We want to thank the reviewer for their time and careful consideration of the manuscript. They have brought several important points to our attention. Reviewer comments are included below in black and our responses are printed inline in blue. *Italic* text is used to quote text in the manuscript.

Reviewer 1

Reviewer 2

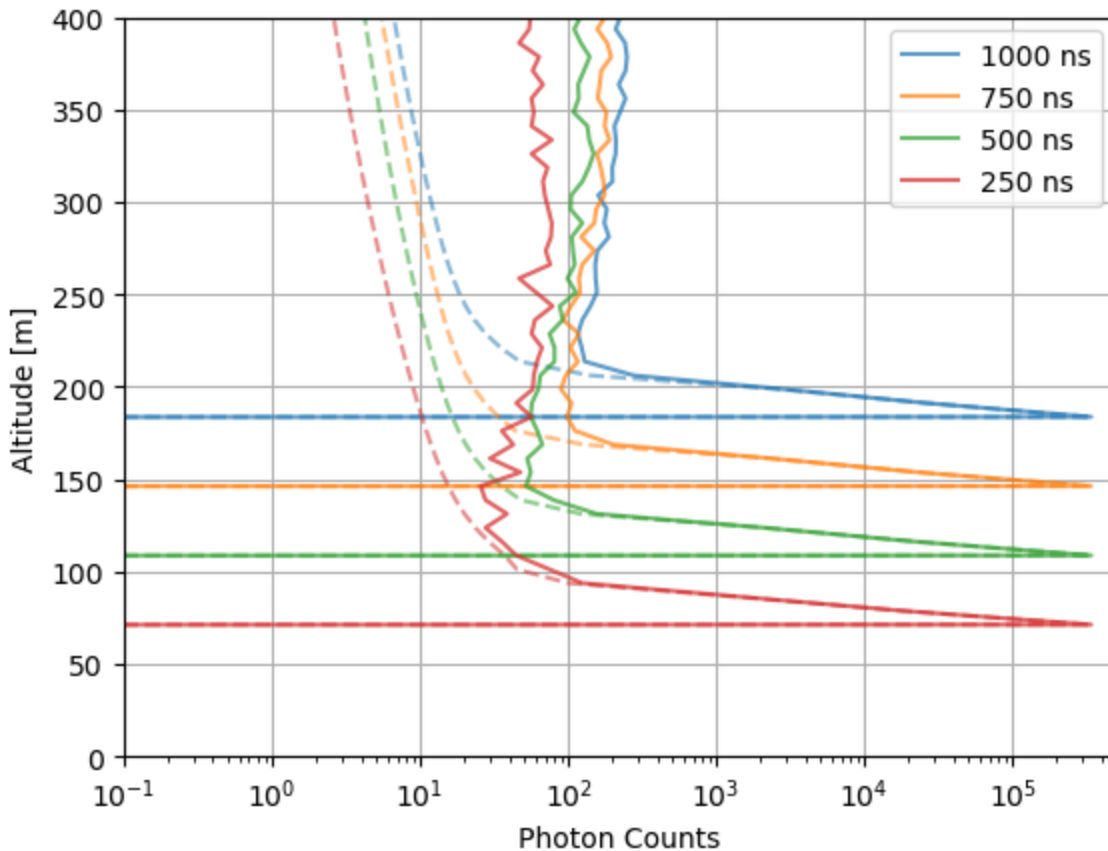
1) Abstract: It is not clear to me why longer pulses should blank the detector. If the energy is distributed over a longer time, the dynamic range of the detector should not be the limit. Please explain it better. Is this only due to the fact that no data can be recorded while the pulse is still on its way out of the laser? Or there are other processes involved (see following point)?

From a simplest, first order perspective the reviewer's description provides an intuitive model for understanding why shorter pulses are needed to see lower. The instrument is effectively blind as the laser pulse exits and therefore a longer pulse forces a higher minimum altitude. Please note that the laser pulses employed by the MPD are much longer than are typical with solid state lasers. Typical MPD laser pulses of 1 μ s result in a blanking range of 150 m. However there appear to be some larger complexities that result in a longer time before accurate data can be recovered. At this point, we don't feel that we fully understand all the contributing factors. While we are willing to discuss these factors (and we continue to investigate them), we also want to be clear that they are also beyond the scope of this particular work.

To help clarify this, we have revised the final paragraph in the masking section to read *In addition to masking due to potential errors in the noise model, the long pulse channels tend to experience a bias in the lower altitudes associated with the pulse length and recovery time of the detector. The way these potential errors impact biases in the instrument and ultimately impacts the minimum altitude of data products is discussed in detail in \cite{Spuler2021}. These errors are in part due to the fact that data is not valid while the pulse is exiting and thus the long 1μ s pulse blanks the receiver (which is electronically gated during the pulse exit) for 150 m. However errors persist in the recovered signals beyond this time and do not appear to linearly scale with the laser pulse length. The exact causes of this "recovery time" effect are still not fully understood and may be related to stray light, detector recovery time after exposure to high optical intensity (while gated), afterpulsing, transient effects of detector gating or a combination of all four. Ultimately, sloping baseline biases and transient detector responses can cause errors in the retrieval, particularly at low altitudes where backscatter signals from the atmosphere are relatively weak due to low overlap (see Figure 11 in \cite{Spuler2021}). The recovery time after the pulse exits does not appear to extend as high with the shorter pulse length. This effect is not encapsulated in the NLL so a heuristic solution of masking data below*

500 m on the long-pulse observations and below 65 m or 80 m (for 100 ns and 200 ns pulses, respectively) on the short-pulse channel is employed.

We currently believe that potential contributing factors related to corruption in the backscattered signals at low altitudes are related to combinations of scattering in the instrument, detector afterpulsing, nonlinear optical amplifier response to drive current, residual deadtime errors, detector response to the gate and detector illumination while gated.

Factors such as scattering can cause the exit pulse to extend beyond the actual “on” duration due to increased optical path length, but we presently believe that scattering probably just dictates the *amount* of corrupting pulse signal coupled into the receiver. Extended tails in the response are believed to be the product of afterpulsing in the detector AND nonlinear responses in the optical amplifier (after the current is turned off, similar to afterpulsing, trapped carriers recombine to continue to emit a weak, decaying signal which can be scattered into the receiver). These tails, because they are not constant in range, and atmospheric signals are comparatively low, can cause biases in DIAL retrievals. Gating the detector significantly decreases the amount of afterpulsing from the detectors, but the detector still may experience some recovery time after the gate is reenabled, resulting in a sloping baseline response effect. Additionally, the baseline response of the detector does appear to be influenced by the light exposure even while the gate is applied. Finally, deadtime, while corrected using more advanced methods (see Kirchhoff et al 2025) may not be adequately addressed due to insufficient range resolution at the steepest parts of the baseline response curves.

Many of these terms will tend to dominate the backscatter signals nearest the instrument where signal photon counts are low and thus contribute significant errors. Note that removing these terms relies on accurate estimates of the baselines, doesn't account for some of the stated potential factors, and poor correction can increase errors. The figure below shows some example data of a system transmitting 4 different laser pulse lengths along with the associated measured baseline calibrations (dashed lines). While it's clear that the shorter pulses produce valid data at lower altitudes, the exact location where that data is valid is likely beyond the point where the detector gate is turned on (something seen circumstantially based on the fact that the retrieval is biased).

In order to push retrievals lower, we will need to better understand these kinds of effects and how they can be characterized and modeled to provide corrections or uncertainty estimates. This is an area we are actively working on, but for now, leveraging a combination of multiple pulse lengths appears to help address the problem without comprehensive knowledge of it.
